World Forum for Harmonization of Vehicle Regulations**Working Party on Automated/Autonomous and Connected Vehicles****Twelfth session**

Automated/autonomous and connected vehicles:**UN Regulation on Automated Lane Keeping System****Proposal for amendments to UN Regulation No. 157
(Automated Lane Keeping System)****Submitted by the leadership of the special interest group on
UN Regulation No. 157 ***

The text reproduced below reflects the discussion state of play of the Special Interest Group on UN Regulation No. 157 (Automated Lane Keeping System) presented to the Working Party on Automated/Autonomous and Connected Vehicles (GRVA) at the eleventh session, on raising the specified maximum speed of Automated Lane Keeping System (ALKS) up to 130 km/h. The text below incorporates the contents of ECE/TRANS/WP.29/GRVA/2020/32, ECE/TRANS/WP.29/GRVA/2021/31 and GRVA-11-33 and therefore replaces the aforementioned documents. Modifications to the existing text of UN Regulation No. 157 (incl. Supplement 2) are marked in bold for new or strikethrough for deleted characters. Open issues are noted in square brackets.

Figure 1 ~~Skilled~~ **Competent and careful human performance model**

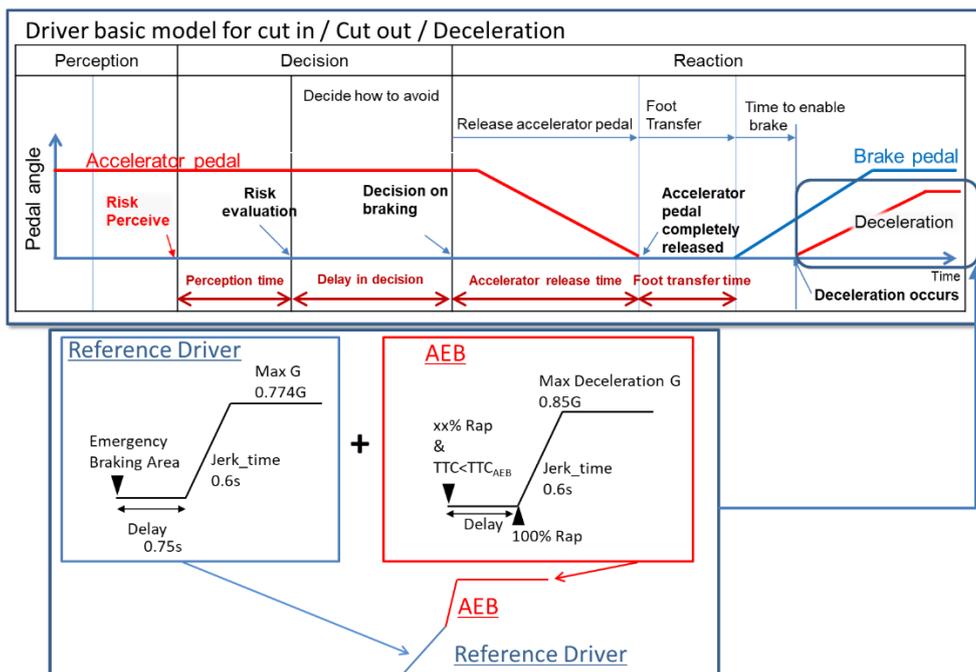
3.3.1. **In the first performance model**, the avoidance capability of the driver model is assumed to be only by braking. The driver model is separated into the following three segments: "Perception"; "Decision"; and, "Reaction". The following diagram in **Figure 1** is a visual representation of these segments.:

3.3.1.1. To determine conditions under which Automated Lane Keeping Systems (ALKS) shall avoid a collision, performance model factors for these three segments in the following **Table 1** table should be used as the performance model of ALKS considering attentive human drivers’ ~~behavior~~ **behaviour** with ADAS.

Figure 14

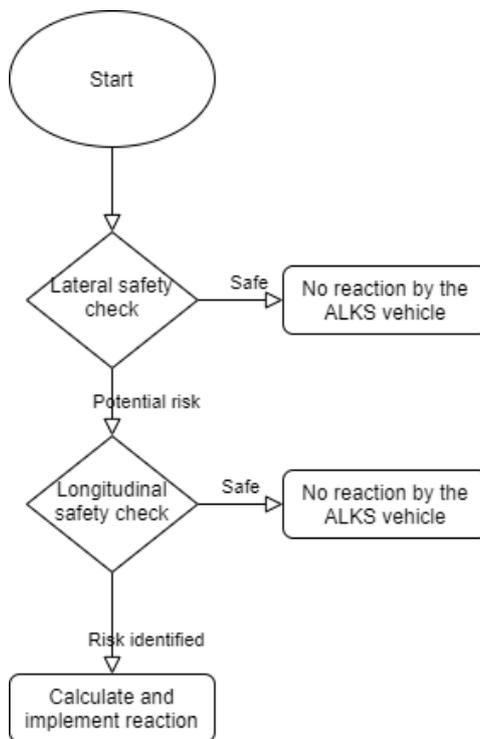
3.4.1. In the second performance model, it is assumed that the driver can anticipate the risk of a collision and apply proportionate braking. In this case, the performance model considers the following three actions: "Lateral Safety Check"; "Longitudinal Safety Check"; and, "Reaction". A Reaction is implemented only if the Lateral and Longitudinal Safety Checks identify a risk of imminent collision. The diagram reported in Figure 2 provides a visual representation of the decision flow followed by the driver in the second performance model for the case of the cut-in traffic critical scenario.
